BOARD OF ARCHITECTURAL REVIEW
AND
PLANNING COMMISSION
PUBLIC HEARING
JANUARY 27, 2011 - 6:30 PM
TUKWILA CITY HALL COUNCIL CHAMBERS

STAFF REPORT

FILE NUMBER: L10-077, Public Hearing Design Review Approval and L11-004, Parking Variance Application

REQUEST: Taco Time has submitted applications for construction of a new 2,381 square feet restaurant along with other site improvements including parking and landscaping. Specifically, Taco Time is requesting the Board of Architectural Review for approval of the design review application. Additionally the proposal includes a request to the Planning Commission for 25% reduction in the minimum parking requirements for the proposed use.

NORTH ELEVATION
1/4"=1'-0"

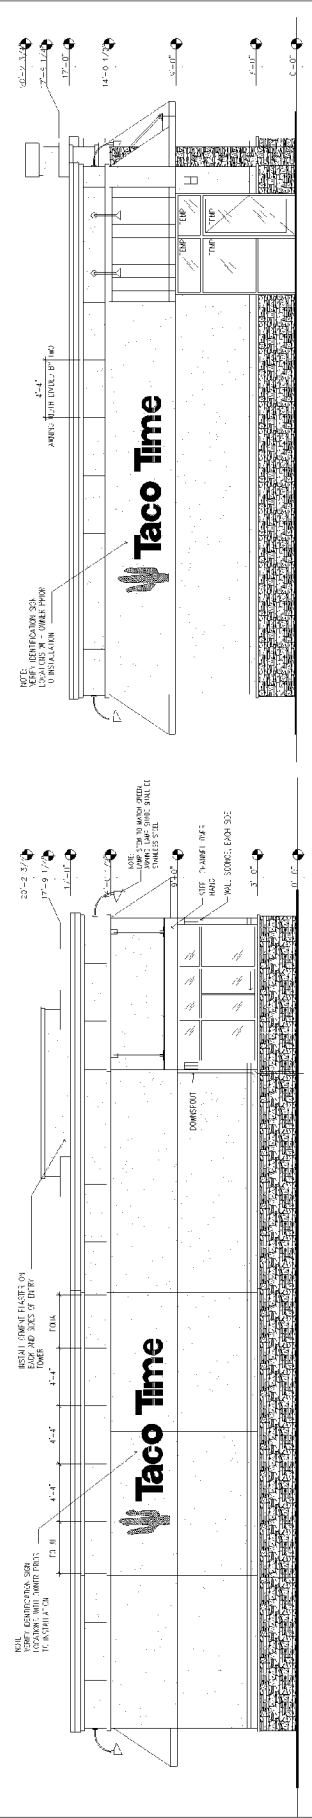
Given the angle of TIB at the project site, the north elevation will be prominent to drivers along the street. The north elevation is essentially the "front" of the building. The design of the building utilizes several awnings along the north elevation. These awnings assist in reducing the mass of the building and provide horizontal modulation. A tower element is also used along the north elevation at the main entrance of the building. The applicant has also proposed to install a corner entrance feature along the NE corner of the building which is encouraged in the TIBDM. This entrance will be prominent to drivers traveling south on TIB. Windows are provided along all building facades. These windows allow patrons within the building to view the parking area, TIB and Military Road S. Exterior building lighting is located on all facades (Attachment B, Sheets 2, 3 and 4).

Over half the length of the north elevation includes windows. These windows will allow patrons within the restaurant to view the parking area, TIB, and Military Road S. The applicant has also located three doors to provide access to the restaurant. All three doors can be accessible from the walkways that extend from the Military Road South or TIB. The applicant has also proposed one plaza area along TIB and another outdoor seating area on the site (Attachment B, Sheets 1, 2, 3, and 4).

South Elevation
 1/4" = 1'-0"

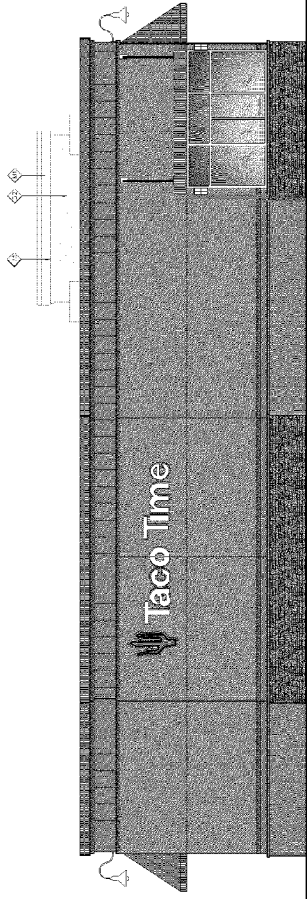
Type II landscaping will be installed along the north and south property lines. The landscaping on the south property line will assist in screening the drive through lane and the south façade which lacks the architectural features of the other walls. A six-foot black vinyl coated chainlink fence will be installed along the north and south property lines. (Attachment B, Sheet 1)
